# White Cross Offshore Wind Farm ES Addendum

Appendix B: The Applicant's Response to  
the MMO and Cefas

<b>Document Code:</b>		WHX001-FLO-CON-ENV-RPT-0003	
<b>Contractor Number:</b>	<b>Document</b>	PC2978-RHD-ZZ-XX-RP-Z-0750	
<b>Version Number:</b>		00	
<b>Date:</b>	Issue	Date	
	01/07/2024		
<b>Prepared by:</b>	TM		<i>Electronic Signature</i>
<b>Checked by:</b>	CB		<i>Electronic Signature</i>
<b>Owned by:</b>	CB		<i>Electronic Signature</i>
<b>Approved by Client :</b>	OG		<i>Electronic Signature</i>

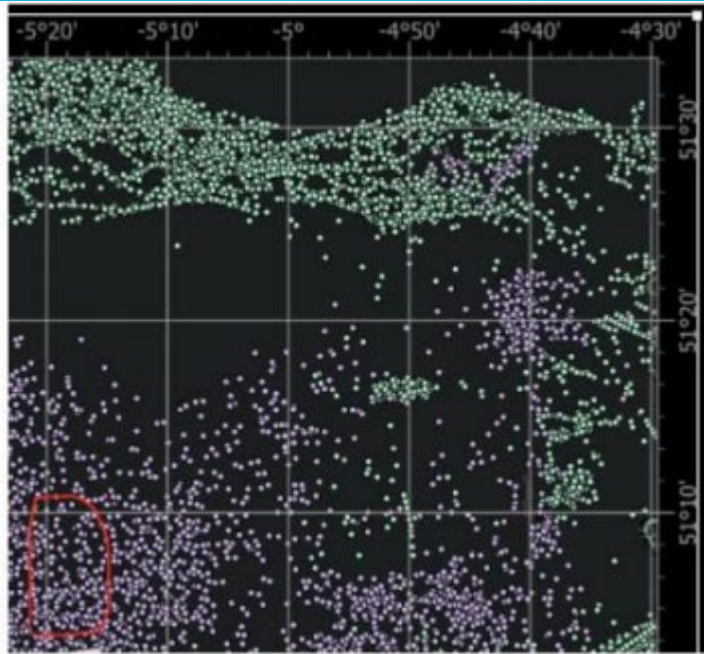
16.10	<p>Devon and Severn IFCA have previously supplied charts showing fishing activity gathered from past surveys undertaken by IFCA and IVMS tracks of the trawling activity in Bideford Bay and North Devon. The MMO requests signposting to the relevant areas within the ES or supporting documents to where these have been used.</p>	<p>A consultation meeting was held with D&amp;S IFCA on 22 September 2022 who advised that they could not share inshore vessel monitoring (I-VMS) and suggested requesting data from the MMO. The MMO were contacted and advised that the iVMS project was in roll-out phase at that time and that they were not in a position to share iVMS data externally. Meeting minutes are provided in <b>Annex 1</b> of this document.</p> <p>Following the initial meeting, IFCA provided a summary of fishing activity based on their own surveys for D&amp;S IFCA District only. In the summary IFCA state that "the level of activity is likely to be an underestimate as the surveys are not fully responded to by fishers. It is important to note that this is therefore not the true picture of the fishing activity nor types of activity taking place outside the 6nm within the White Cross Offshore Wind Farm proposed site or export cable corridor".</p> <p>In addition, the IFCA survey data was based on information from 2009 and 2014 and with low response rate.</p> <p>A second meeting was held with the D&amp;S IFCA on 22/11/2022 to provide a project update and discuss fishing activities in the area. The anonymised fishing ground chart produced from consultation with fishers and fisheries stakeholders included in <b>Chapter 14: Commercial Fisheries</b> was shared and the IFCA confirmed that the data on fishing grounds collected corroborated their data. As data from the consultation undertaken by the Project was more recent and aligned with previous IFCA's survey results, this was</p>

ID	Consultee Comments	Applicant Response
		included in <b>Figure 14.2</b> of <b>Chapter 14: Commercial Fisheries</b> of the <b>Offshore ES</b> .
16.11	<p>In Annex 4 of the Commercial Fisheries Chapter 14 the summary of Devon and Severn IFCA Byelaws is not correct and MMO requests that this is amended. Devon and Severn IFCA's website contains the management measures in place for its District. Devon and Severn IFCA has permit conditions associated with its Mobile Fishing, Potting, Netting and Diving Permit Byelaws. The management measures can be read <a href="https://www.devonandsevernifca.gov.uk/enforcement-and-legislation/current-permit-byelaws-permit-conditions/">here</a>: <a href="https://www.devonandsevernifca.gov.uk/enforcement-and-legislation/current-permit-byelaws-permit-conditions/">https://www.devonandsevernifca.gov.uk/enforcement-and-legislation/current-permit-byelaws-permit-conditions/</a></p>	<p>The Applicant will refer to the link provided for information and potential future updates on management measures of relevance to the Devon and Severn IFCA.</p>

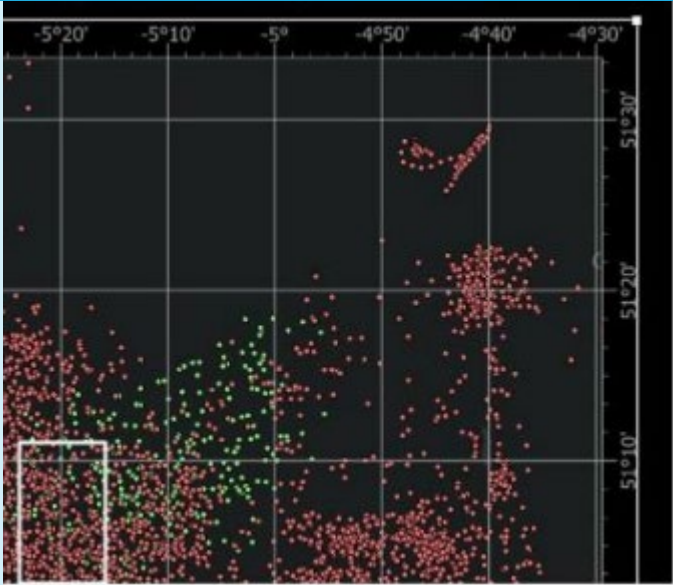
17.3	<p>The below evidence highlights the CFPO fleet footprint on the Project site and shows the level of displacement this will cause, both during survey and construction works, as well as permanent displacement once the site is running. CFPO data (CFPO VMS data from 2014-2021) and evidence for Project turbine site: Purple = static gear (nets and pots) Green = mobile gear (trawl and beam trawl) Polygons in lower left corner = White Cross OWF array area.</p>	<p>The Applicant welcomes the detailed information provided on the distribution of CFPO's vessels activity and the feedback on their concerns over the impact of the Project.</p> <p>It is not clear from the information provided, however, whether the VMS records shown in the charts provided are of vessels engaged in fishing activity or in transit. Similarly, it is unknown what methodology has been used to calculate the loss of catch stated in the CFP's response.</p> <p>WCOWL highlights that VMS data combined with logbook data publicly available from the MMO, was used to inform the assessment presented in <b>Chapter 14: Commercial Fisheries</b> of the <b>Offshore ES</b>. This includes information from all UK registered vessels including those which are members of the CFPO.</p> <p>As shown in <b>Appendix 14.A: Commercial Fisheries Technical Report, Figure 6.14</b>, MMO VMS data indicates that the level of</p>

ID	Consultee Comments	Applicant Response
	 <p data-bbox="309 986 1160 1058">The below shows potting as red and netting as green. The White Cross site has both fishing methods taking place within it.</p>	<p data-bbox="1182 260 2031 331">potting activity that takes place within the Wind Farm Site is very low.</p> <p data-bbox="1182 352 2031 691">The total catch value of £ 500,000 over a 30-year period for the Wind Farm Site, stated in CFPO's response would equate to a total of approximately £16,700 per year. Assuming this total relates to two or three vessels, the catch value of the site for each vessel would be £8,350 and £5,600 annually, respectively. It is important to note that loss of access to the site does not necessarily mean loss of income as the affected vessels would be able to target grounds elsewhere. With the above in mind the impact on these vessels is expected to be minimal and not significant.</p> <p data-bbox="1182 711 2031 1010">In this context it is also important to note that the assessment presented in <b>Chapter 14: Commercial Fisheries</b> is based on the worst-case scenario that fishing cannot resume across the whole array site. As shown in <b>Figure 5.2</b> of <b>Chapter 5: Project Description</b> of the <b>Offshore ES</b> project infrastructure is only expected to be installed in approximately 20% of the total array area. Therefore, the area potentially lost for fishing during operation is expected to be much smaller.</p> <p data-bbox="1182 1031 2031 1137">Fishing along the export cable corridor will be able to resume - cables will be buried and protected where burial cannot be achieved.</p> <p data-bbox="1182 1158 2031 1310"><b>Chapter 14: Commercial Fisheries</b> identified an impact of <b>minor significance</b> on UK fishing vessels and as such, no additional mitigation was proposed in respect of the operational phase.</p>

Title:  
**Whiting Spawning Fleeing Model**

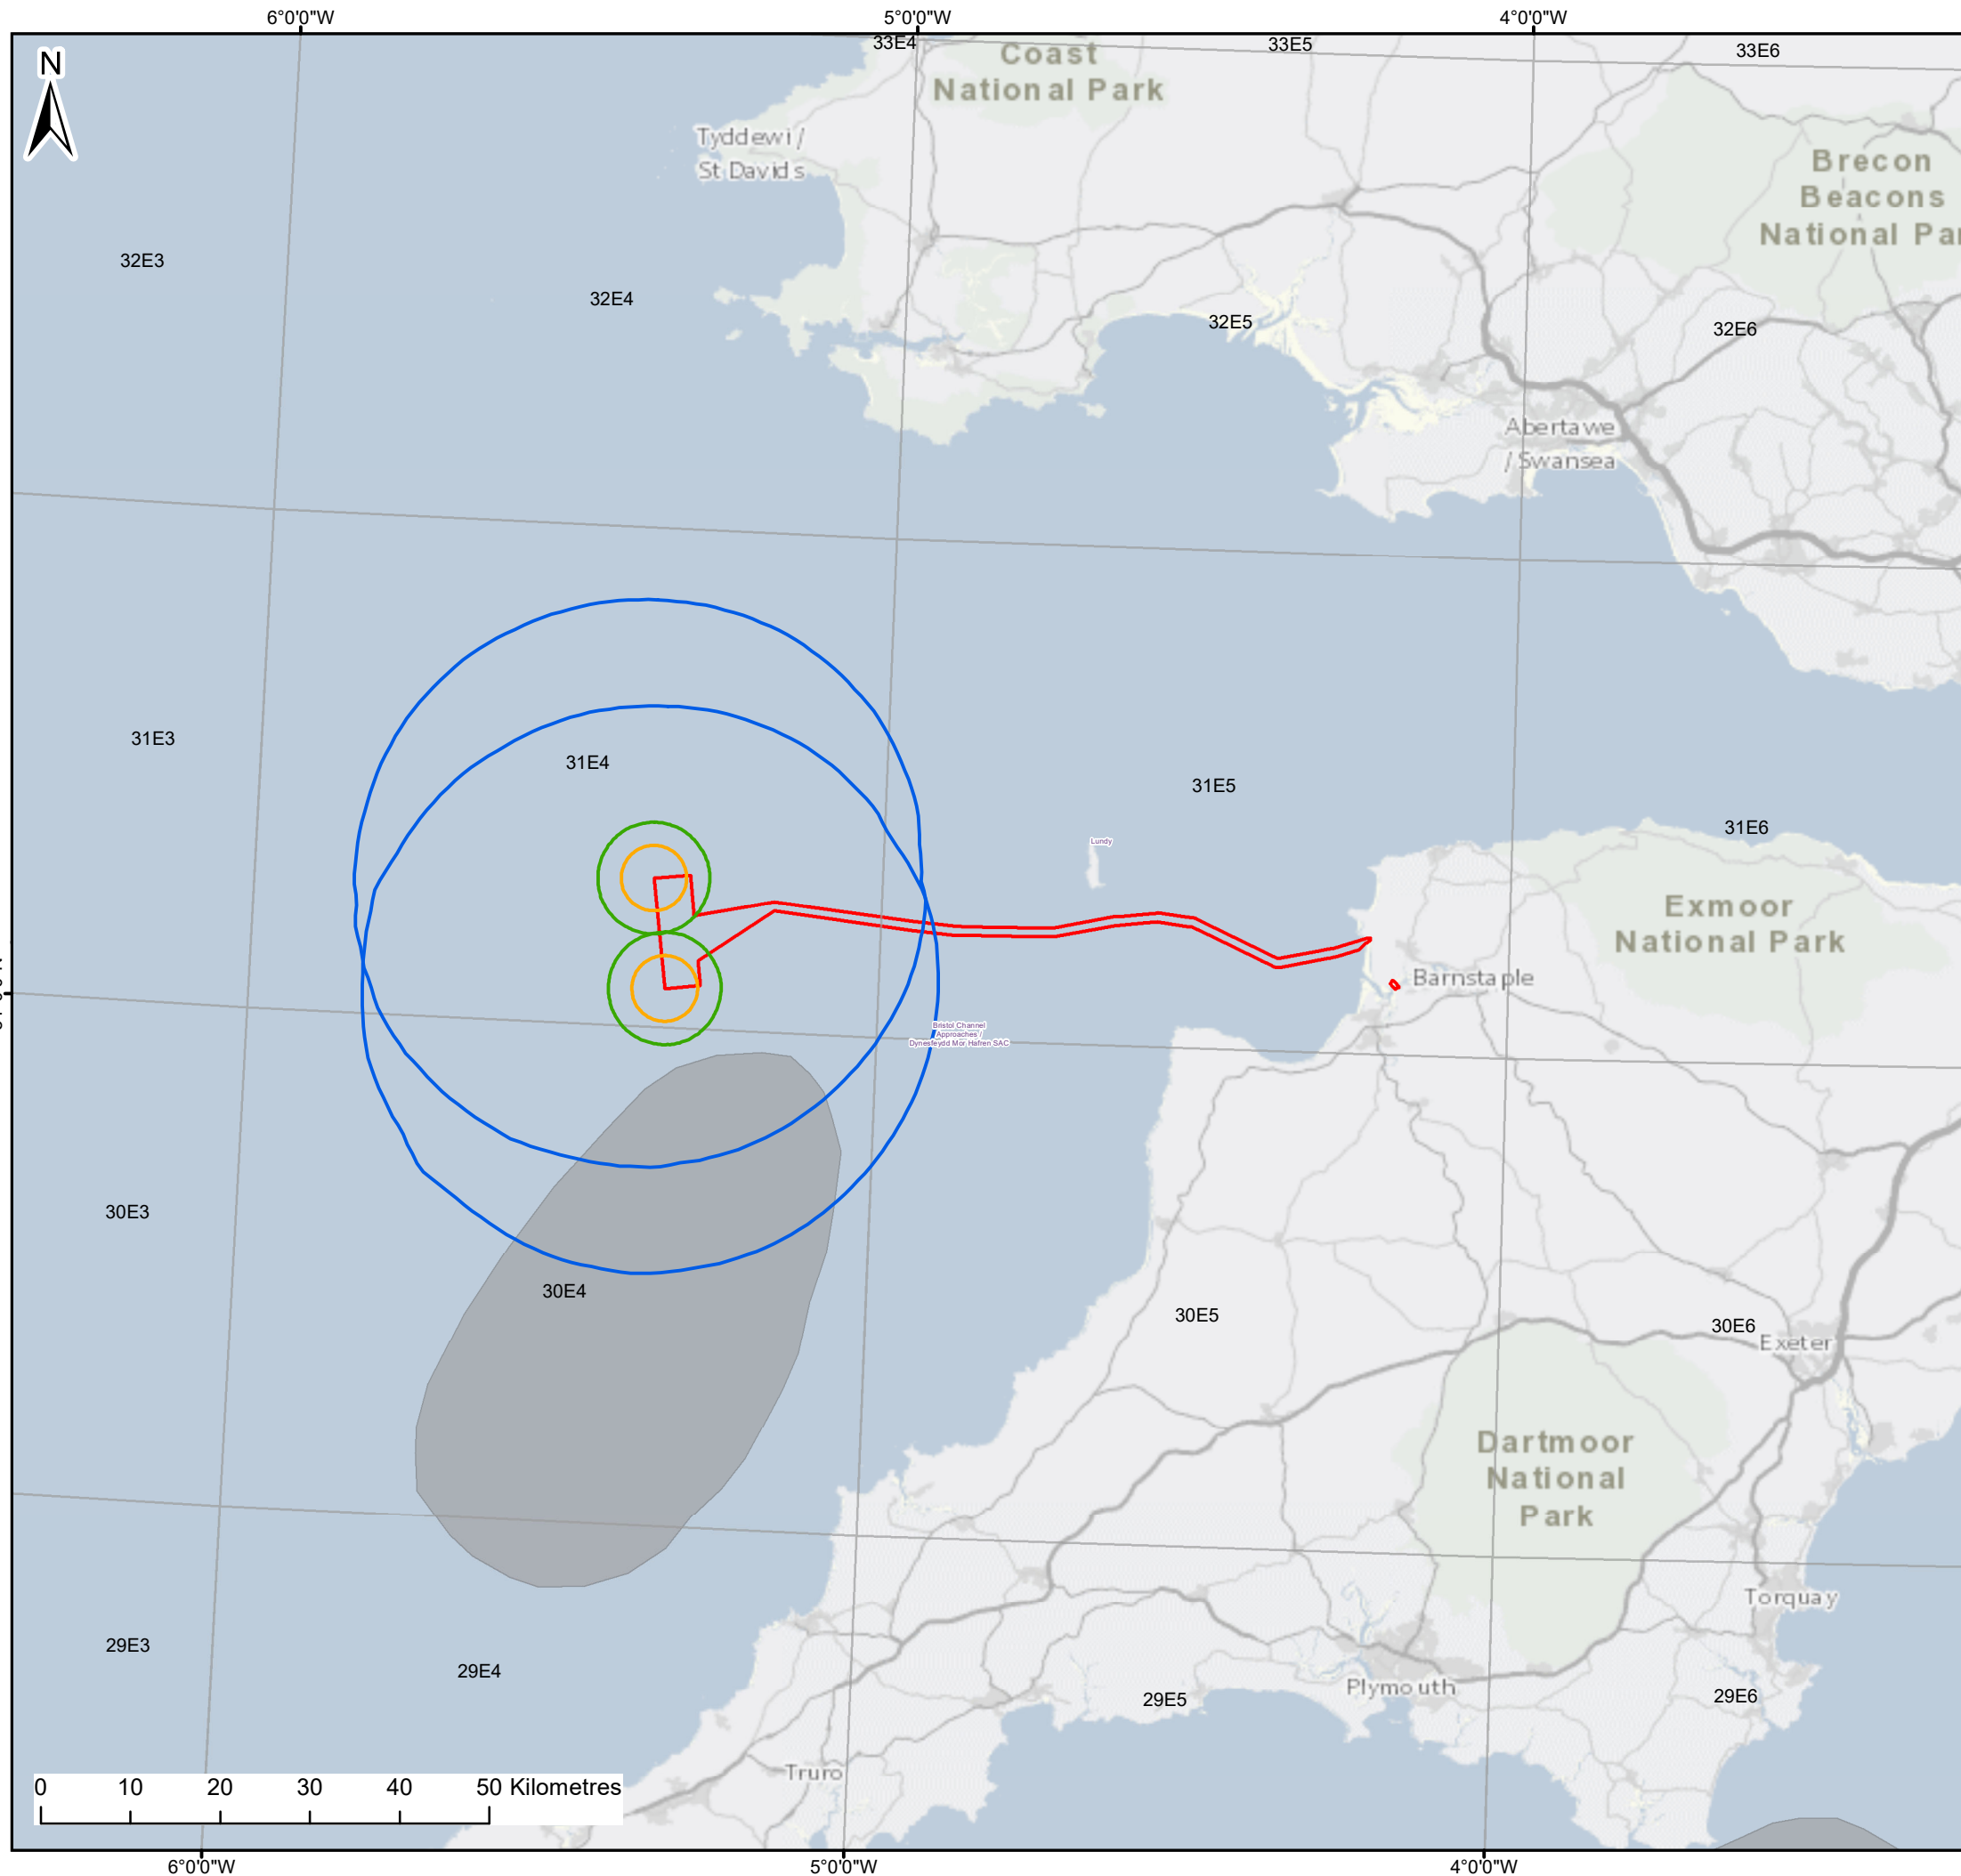
Comment ID	MMO/Cefas Comments	Applicant Response
		<p><b>Figure 4, Figure 5 and Figure 6)</b> and whiting (<b>Figure 7, Figure 8 and Figure 9</b>). These are discussed below:</p> <ul style="list-style-type: none"> <li> <p><b>Cod: Figure 4</b> presents the fleeing model at 186db (i.e. TTS) for both WTG locations and the OSP. In all cases there is some overlap with the spawning area, with the greatest from the OSP. <b>Figure 5</b> presents the stationary model for the WTGs and shows that there is overlap of impact with the spawning area with some of the WTGs being within the area itself. These show that as well as disturbance (TTS) there is also some potential for injury. <b>Figure 6</b> shows the stationary model for the OSP and this has the greatest overlap with the spawning ground, although at a worst case this represents just 4 piles likely to be installed in a single day. As discussed above, given that there is a maximum of 52 piles, it is considered that these could all be installed within a few weeks or a few short campaigns. There would be no months-long campaign required as with the large gigawatt scale projects. Ellis et al (2012) show that spawning takes place from January to April inclusive (with a peak February to March), therefore given such a long period and the duration of piling, the installation period would not represent a material proportion of the spawning season.</p> </li> <li> <p><b>Whiting: Figure 7</b> presents the fleeing model at 186db (i.e. TTS) for both WTG locations and the OSP. There is no overlap of impact from the NW WTG, limited overlap from the SW WTG, with the greatest overlap from the OSP. <b>Figure 8</b> presents</p> </li> </ul>
